TECHNICAL SERVICE BULLETIN

Technical Service Bulletin Number-TSB0005 – Shift-N-Step Ski Alignment

Date – 05/24/2019

Item, Unit or Assembly Affected – Shift-N-Step

Figure 1 Shim Placement

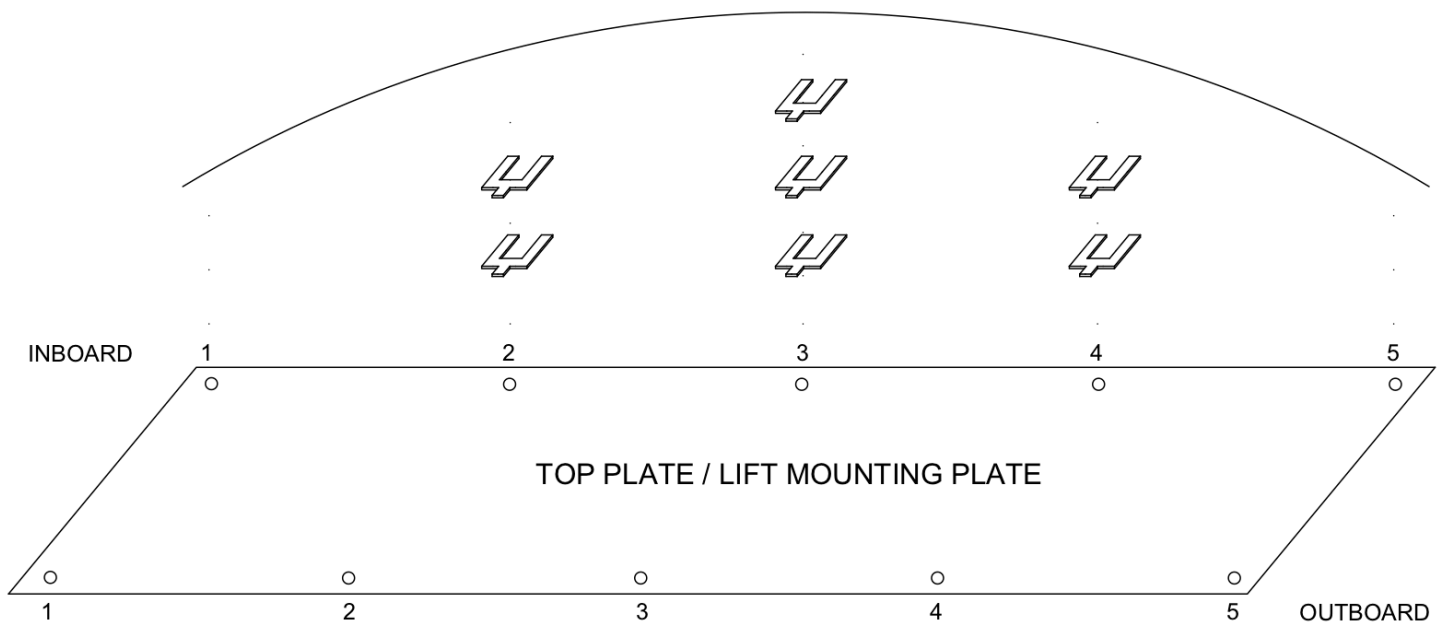
Once the skis are moving freely, secure the lift to the Shift-N-Step while inserting plastic shims to compensate for the curvature of the lift base. The shims should be applied such that they prevent the bolts from bending the skis to the curved shape of the lift base.

Figure 1 below shows the recommended shim pattern:

- Two (2) shims in Column 2, inboard and outboard
- Three (3) shims in Column 3, inboard and outboard
- Two (2) shims in Column 4, inboard and outboard
- A total of 14 shims
